Subject: **Recall Campaign 16V-XXX: ISOFIX Child Restraint System Anchors**

Bulletin: SI B41 01 16

**Model Year 2011-16 BMW X3 SAV, X4 SAC  
ISOFIX Child Restraint System Anchors  
Safety Recall 16V-xxx**

SI B41 01 16  
Body

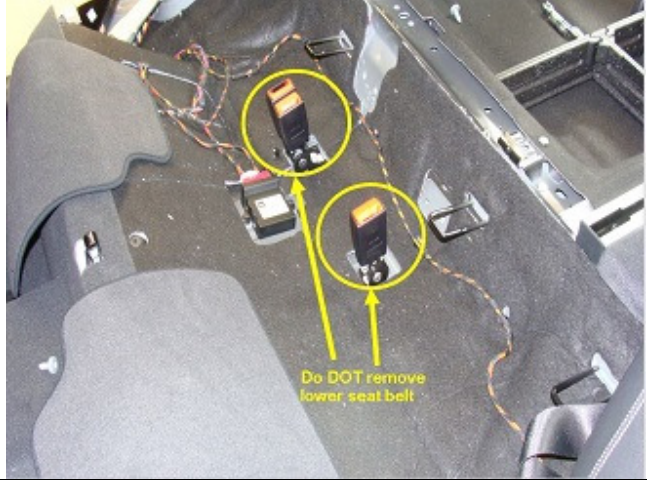
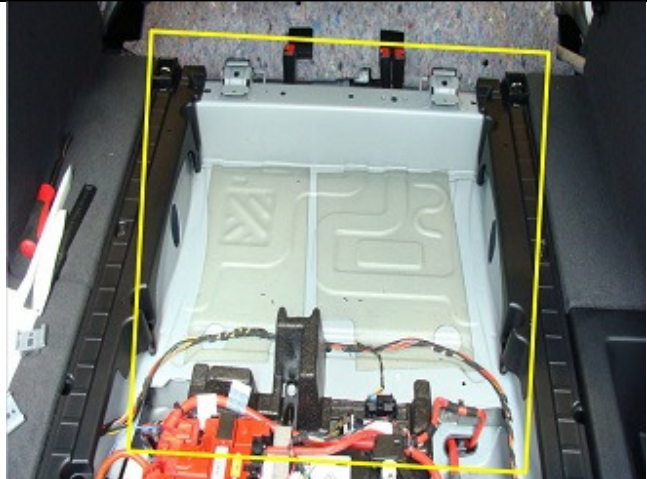
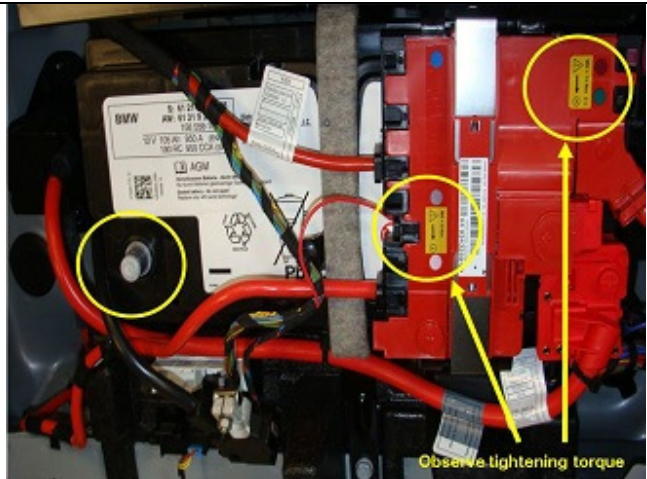
A reinforcing bracket (4) will be welded to the lower anchor bars and the vehicle body.
